Manti-LaSal
National Forest

The Manti-LaSal National Forest has reviewed Plateau Mining Company's ACR responses for five year repermitting of the Star Point Mines and the State Decision Package for the five year renewal and New Lands Application.

Following are our comments on Plateau Mining Company's Five Year Permit Renewal Package:

Copied from Map 30

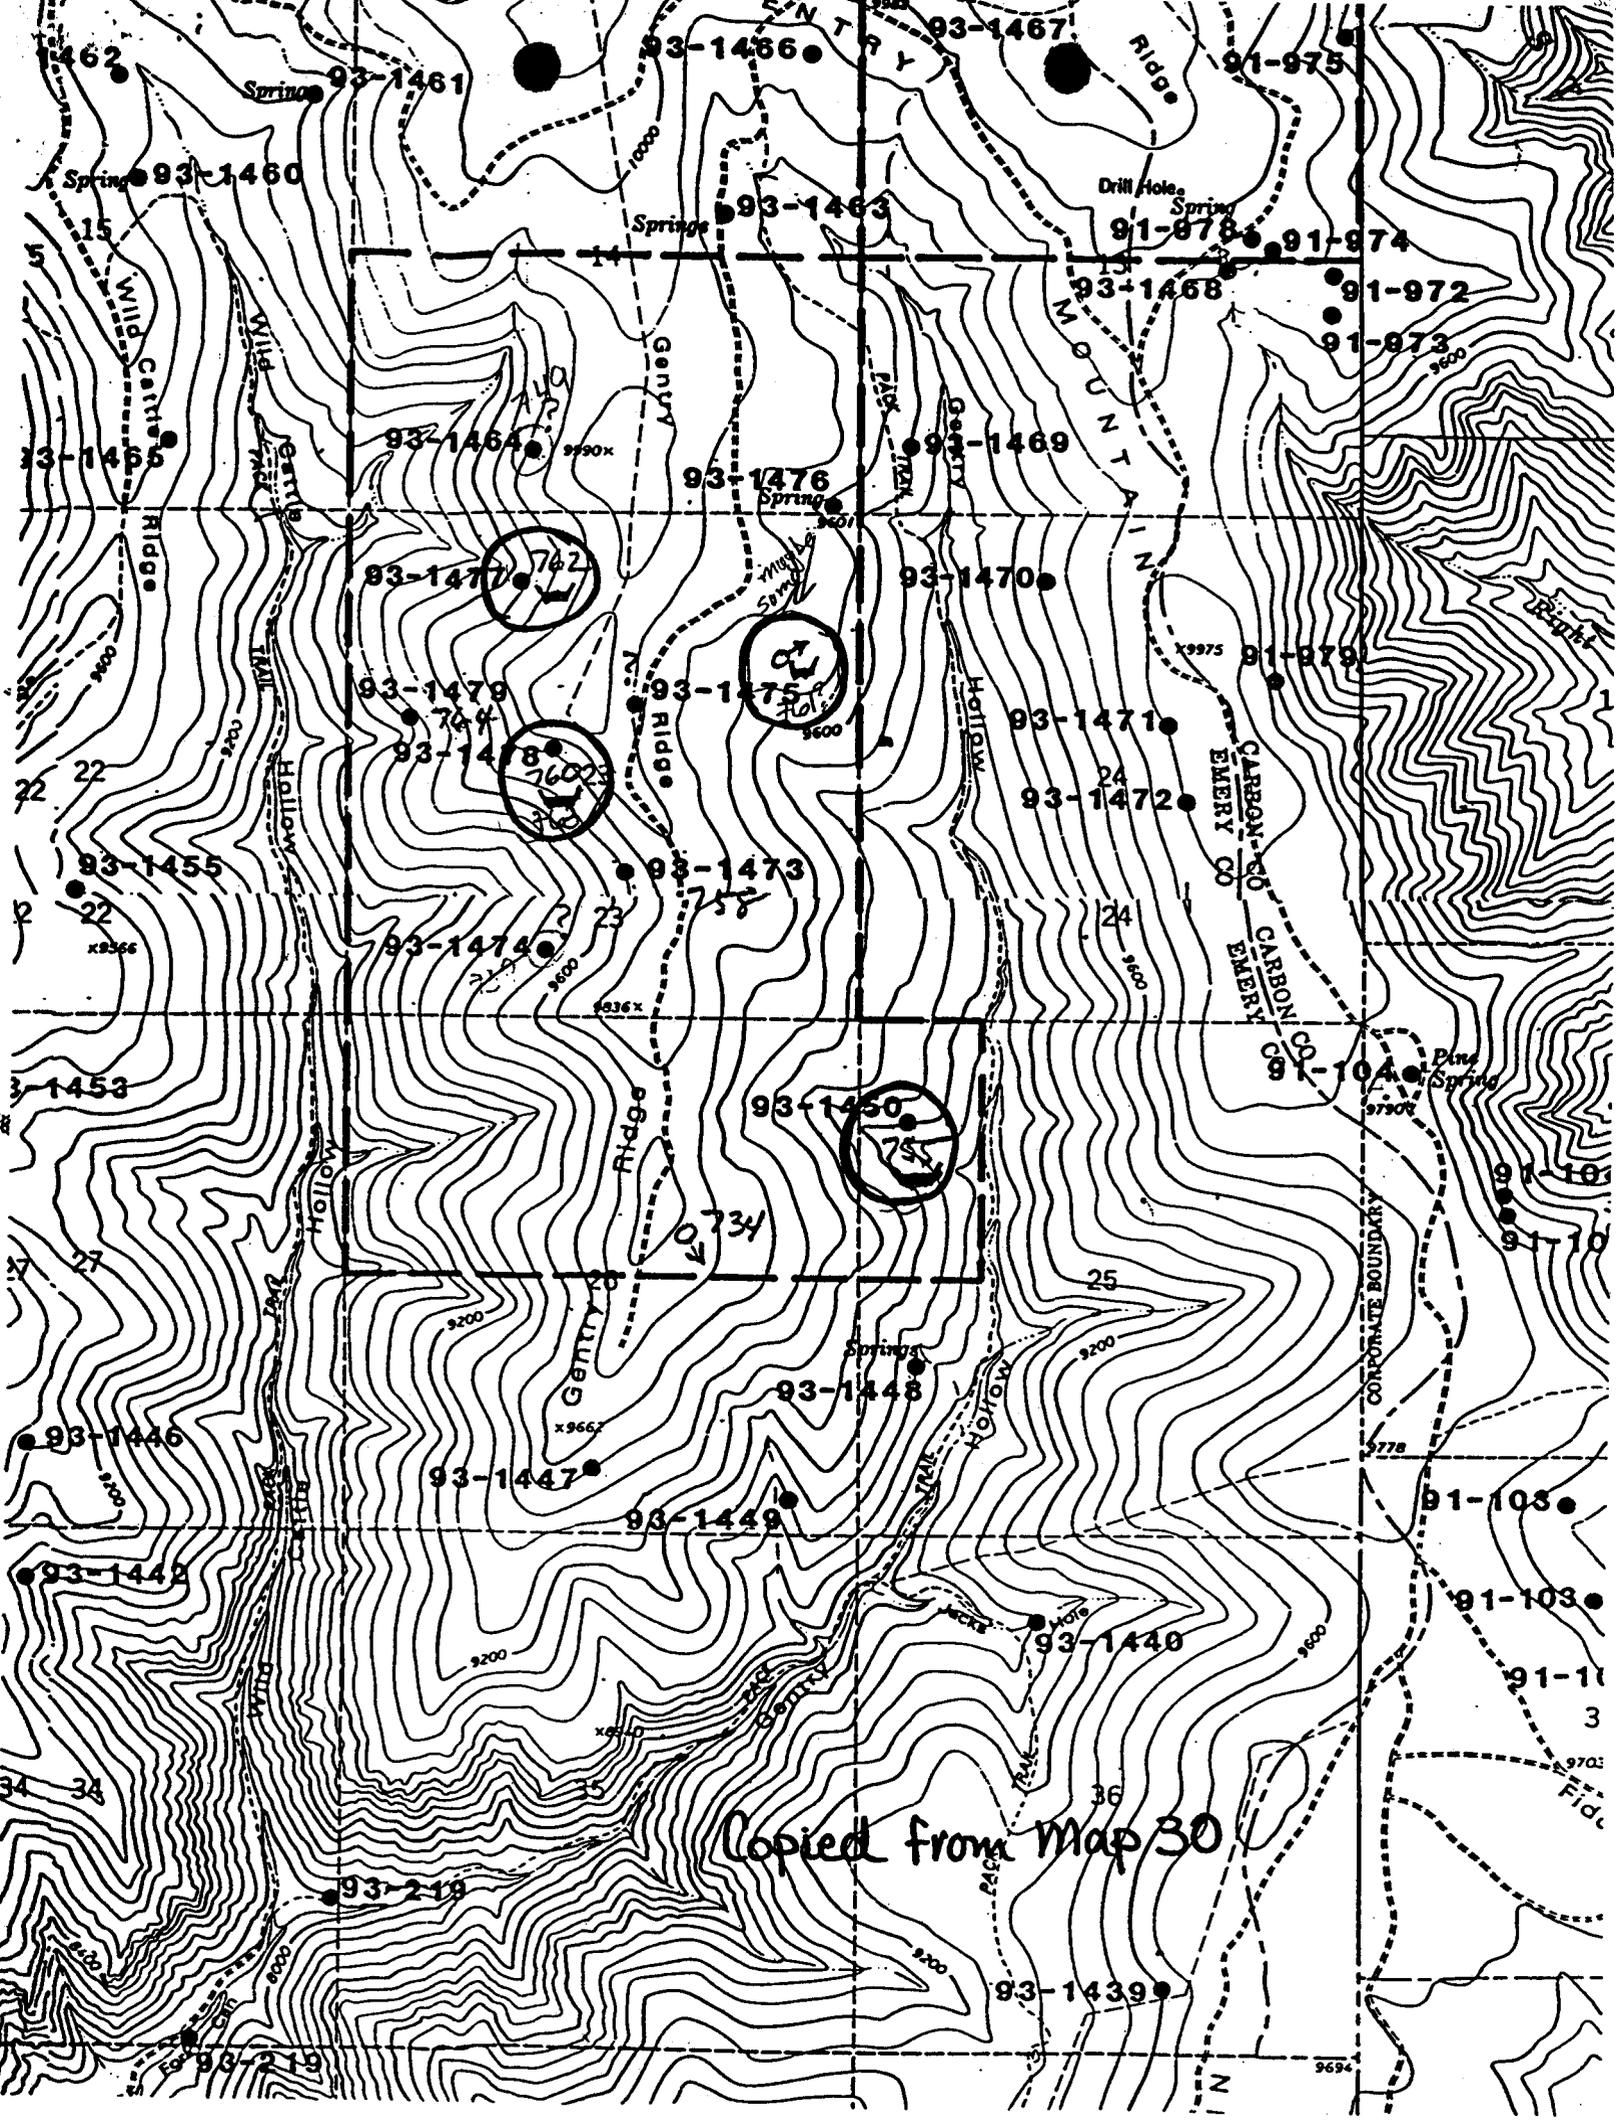
Map 31 shows that only spring 452 on Lease U-13097 will be monitored. Four springs within the lease have been developed by the Forest Service with troughs. They are circled on the enclosed map which was copied from Map 30. One of the springs was not identified by Plateau Mining Company. These springs must be monitored such that impacts from mining will be detected.
